Bid Addendum Two

Project: **Tulip New Utilities Building**
Project No. Tulalip Tribes Project No. 2021-003

Date of Issuance: April 18, 2024

Attachments: [Lighting Plans, sheets E4.0 and E4.1](#)

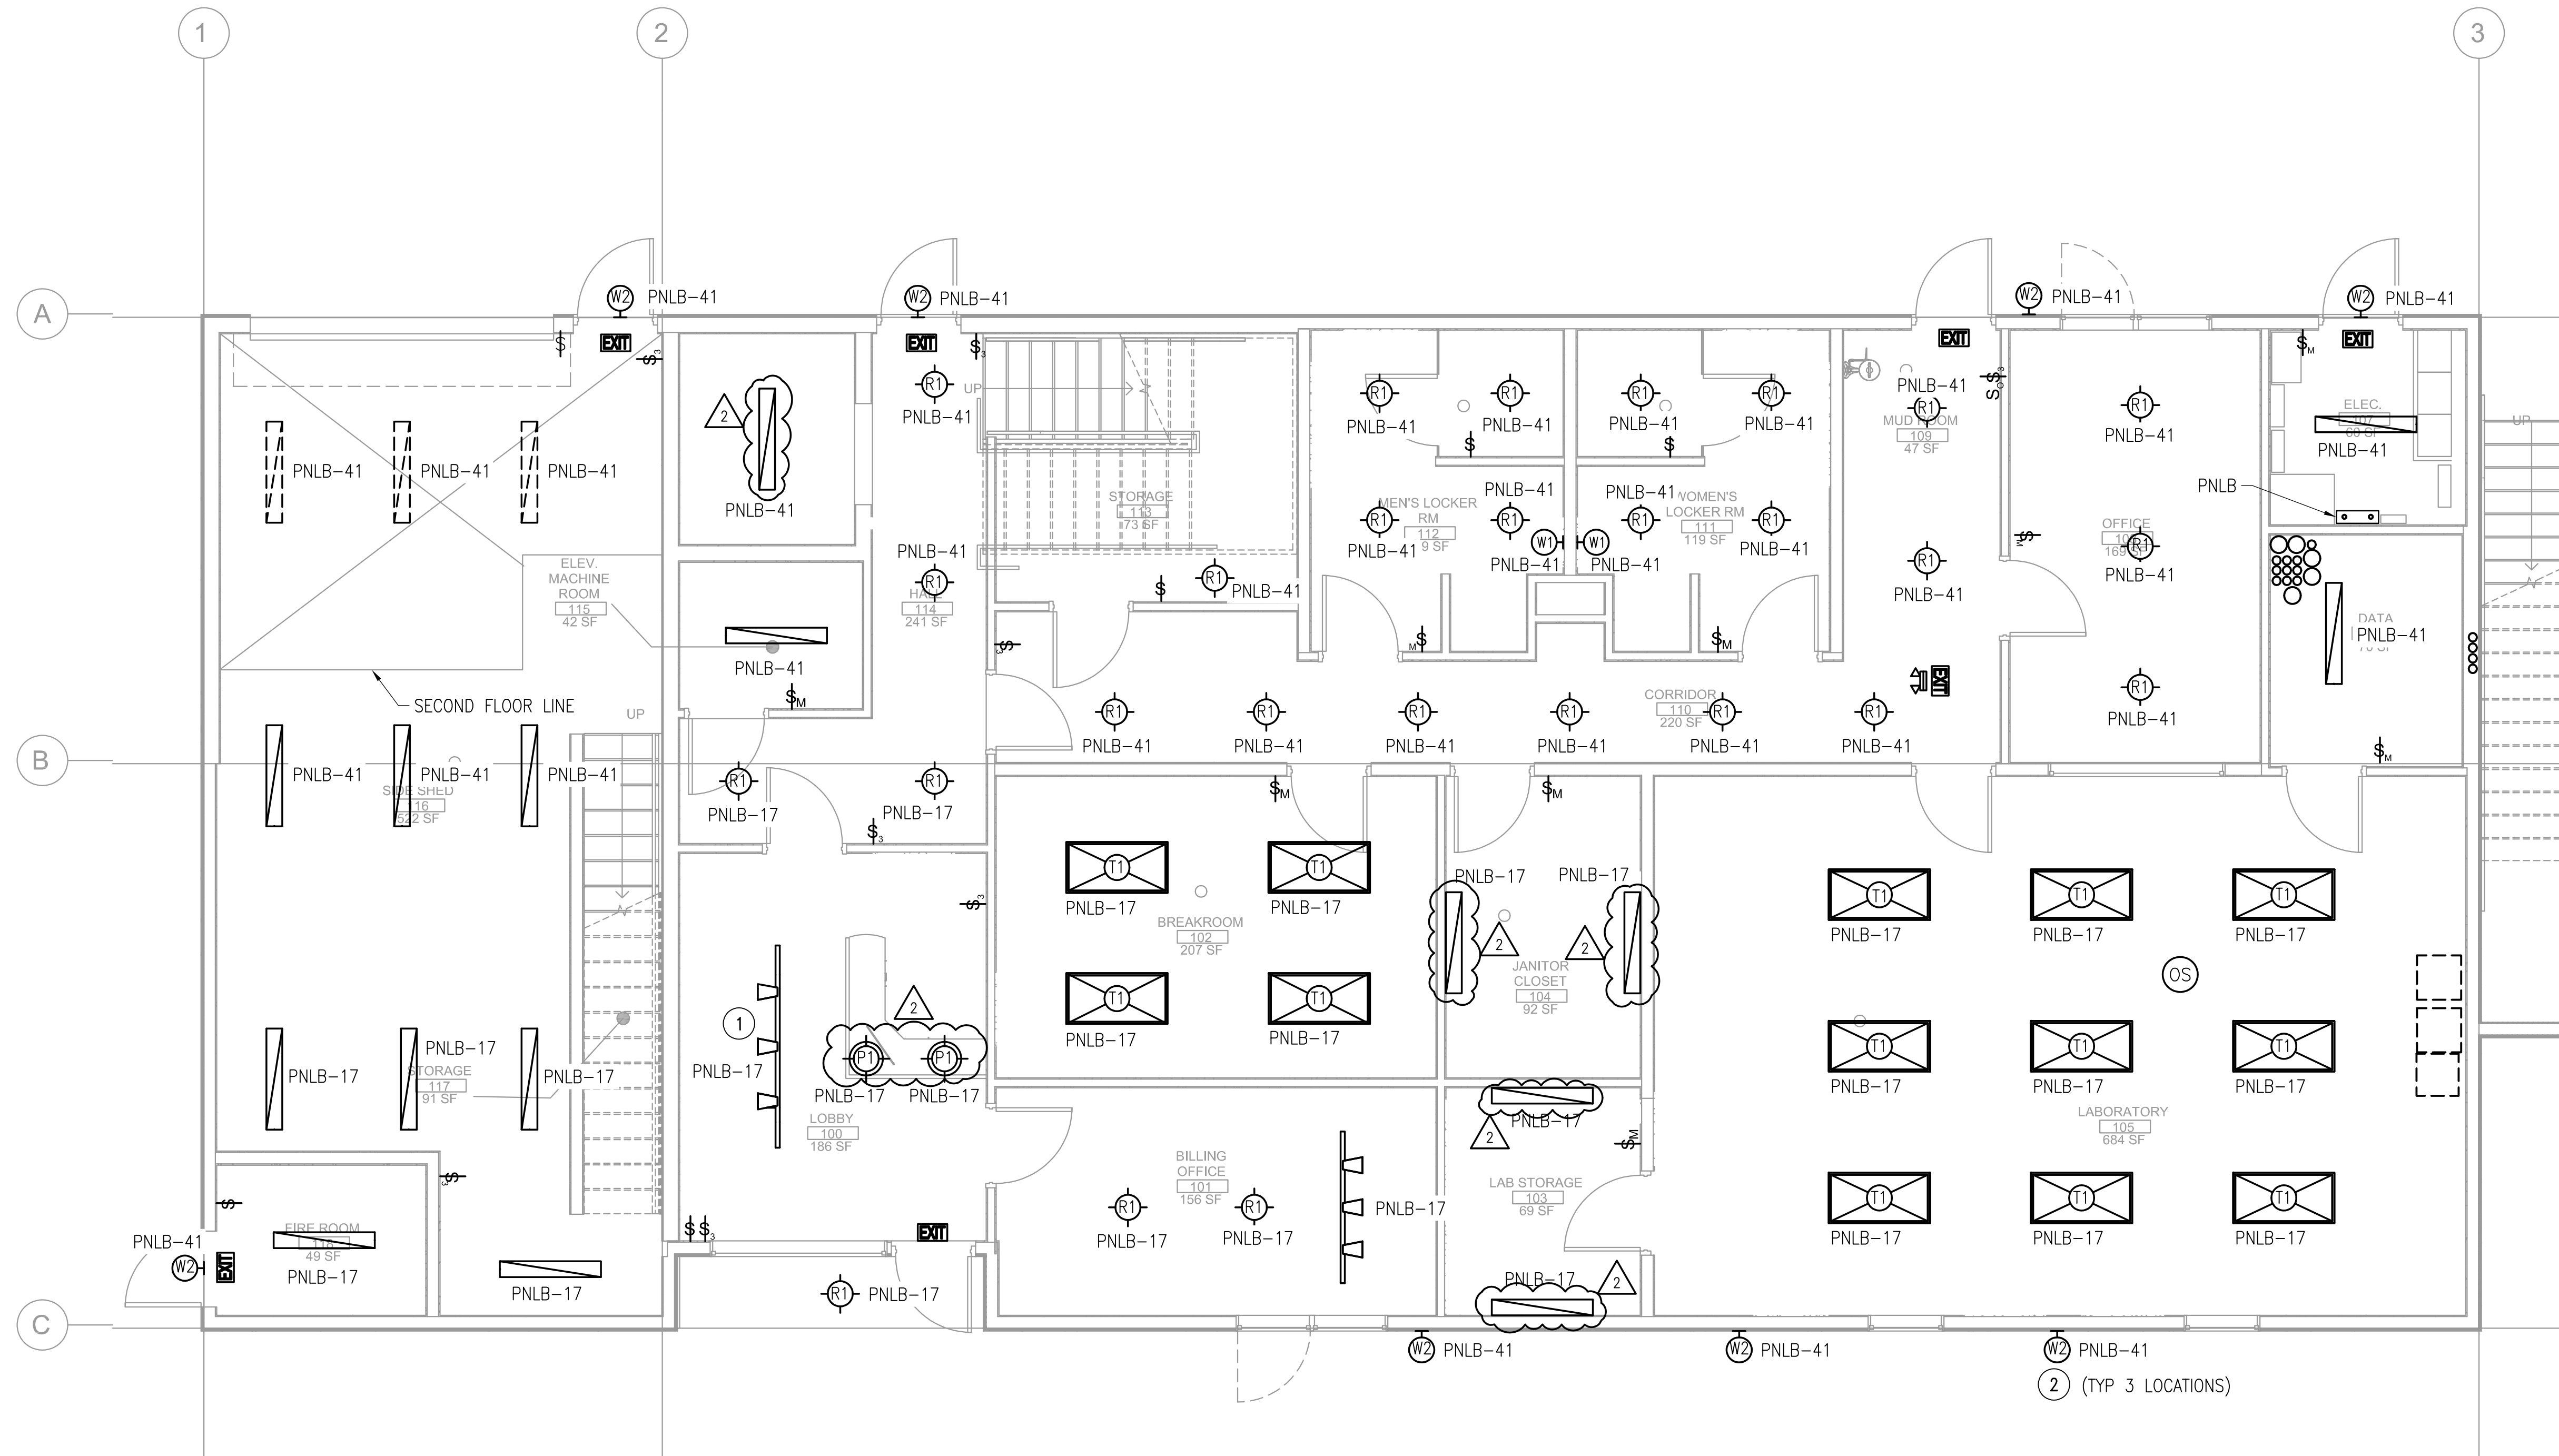
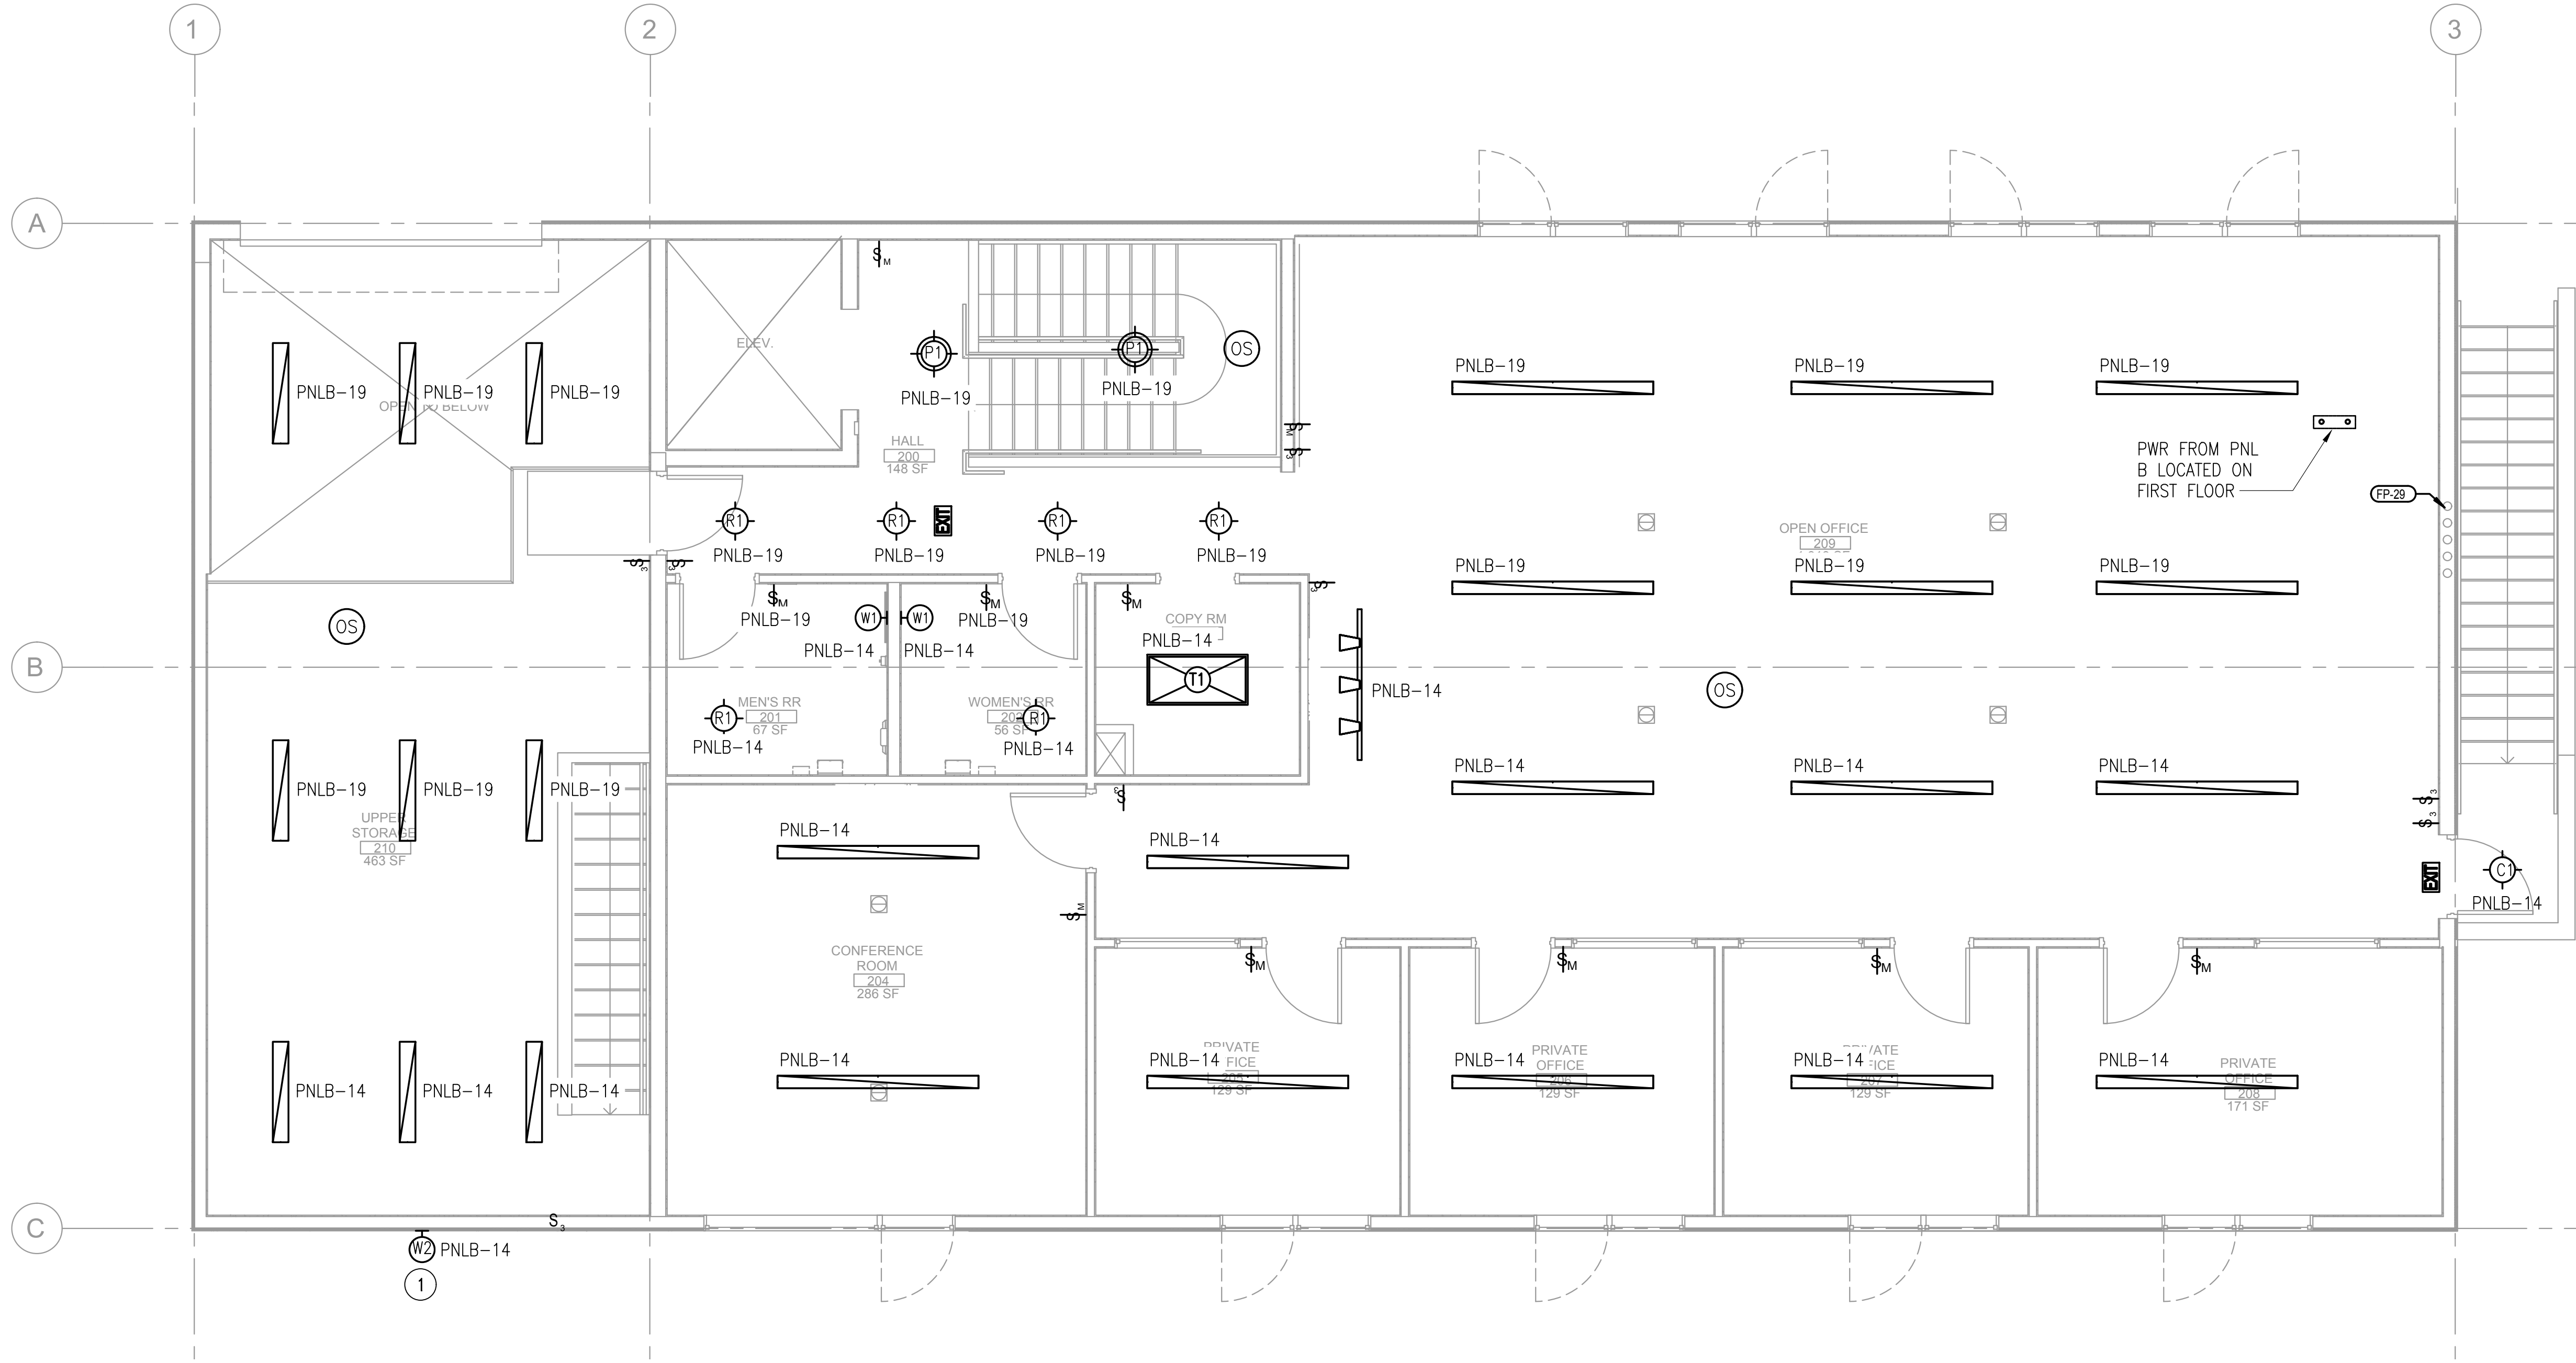
6. In regards to the " Utility Building " Project, I was able to Identify Fixtures on sheet E4.1 in the following rooms, Upper Storage , Conference Room, Private Offices. These fixtures were not identified on the legend. Please provide the ID and Manufacturer.

7. In regards to the " Utility Building " Project, I was able to Identify Fixtures on sheet E4.0 in the following rooms, Elevator Machine Room , Side Shed, Storage Room, Data Room. These fixtures were not identified on the legend. Please provide the ID and Manufacturer
